DBCT Asset Valuation:

Request for Comments

Queensland Competition Authority

Figure 1.1: Sub-Optimal Machine Selection

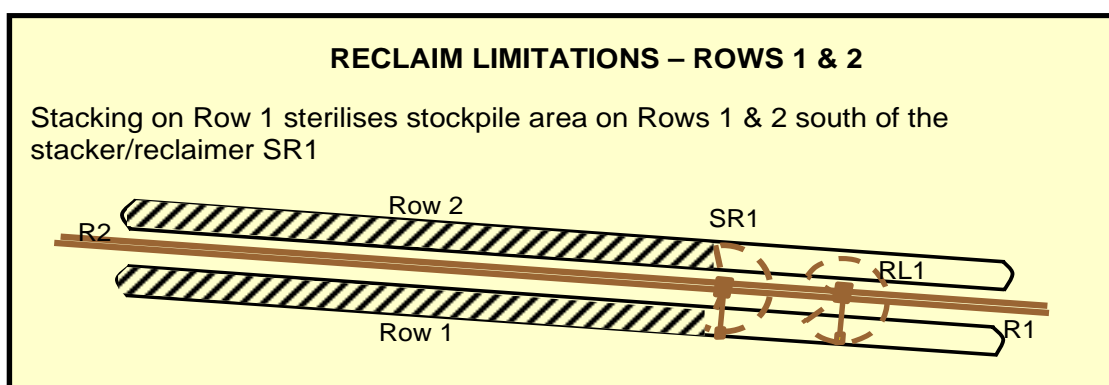
Maunsell believes that, in the early years of the terminal's development, a less than optimum yard machine selection was made. In particular, the yard machine selection of Reclaimer RL 1 in Stage 1 provided a number of constraints to the DBCT operation.

Maunsell noted that the constraint of the original machine selection, Reclaimer RL 1, is highlighted when coal is placed on Row 1. The stockpile management on Rows 1 and 2 is limited by the single stacking capability to Row 1 provided by Stacker/Reclaimer SR 1. By utilising the only machine capable of stacking on Row 1, namely Stacker/Reclaimer SR 1, the stockpile areas to the left of SR1 became unavailable for outloading during the stacking process (see Figure 1.1 below).

In other words, the stockpile areas shaded cannot be accessed by any of the reclaimers. Thus, RL 1 became isolated for certain periods. The choice of yard machine RL 1 in stage 1 unnecessarily restricted the operation of the plant and complicated the stockpile management of the facility and the operator's ability to manage the stockpiles.

Figure 1.2: Optimised Stockyard

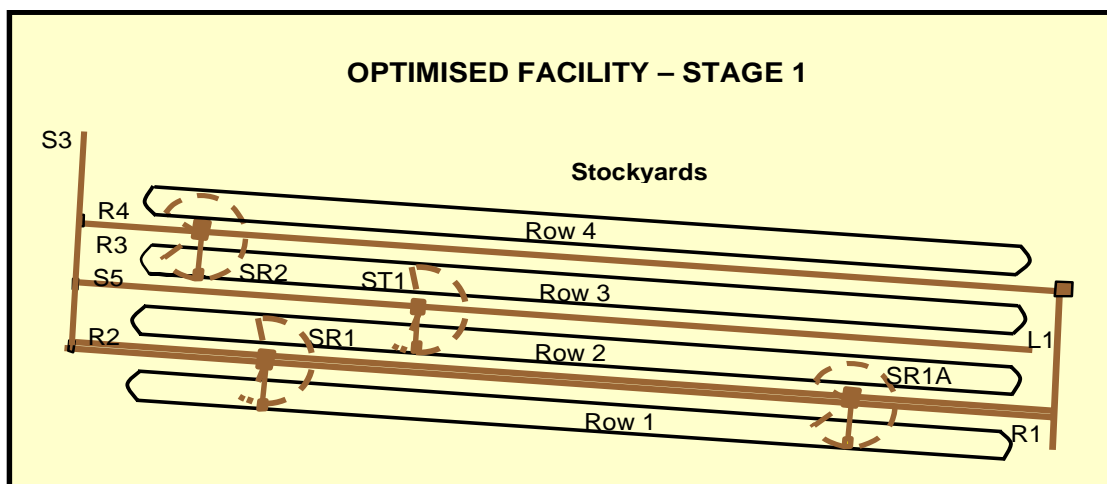
Maunsell argue that the provision of two stacking functions from the outset would have provided flexibility in the management of Rows 1 and 2. As a result, Maunsell propose optimising out RL 1 and replacing it with a second stacker/reclaimer identified as SR1A (see Figure 1.2). Maunsell's recommended configuration therefore includes two stacker/reclaimers on bund 2. By providing SR1A, Maunsell believes the required flexibility and increased plant

capacity would have been achieved in line with subsequent plant expansions at the terminal (i.e. two stacker/reclaimers per bund). This optimisation also necessitated extending the tail end of conveyor R1 and increasing the transfer station size.

Maunsell argue that the real benefit of installing SR1A is more obvious in the later stages. In particular, Stacker ST 2 and the associated feeds system were primarily installed in Stage 5 to alleviate stockpile management issues created by the RL 1 machine selection. However, with the selection of SR1A, other equipment becomes redundant such as conveyors S6A, Transfer Station S6A to S6, Conveyors S6 and Stacker ST 2. As a result, Maunsell proposes that these assets be optimised out on the basis of a sub-optimal design decision at the time the original decision was made.

- (i) Was the design decision sub-optimal at the time the decision was made, in that the constraints identified by Maunsell should have, and could have, been foreseen at the time the decision was made?
- (ii) Are there any reasons why the proposed optimisation is technically inappropriate? For example, is it incompatible with the DBCT site, or would it reduce the current capacity of the terminal; and
- (iii) Are there any other comments you believe are relevant to optimising the stockyard?
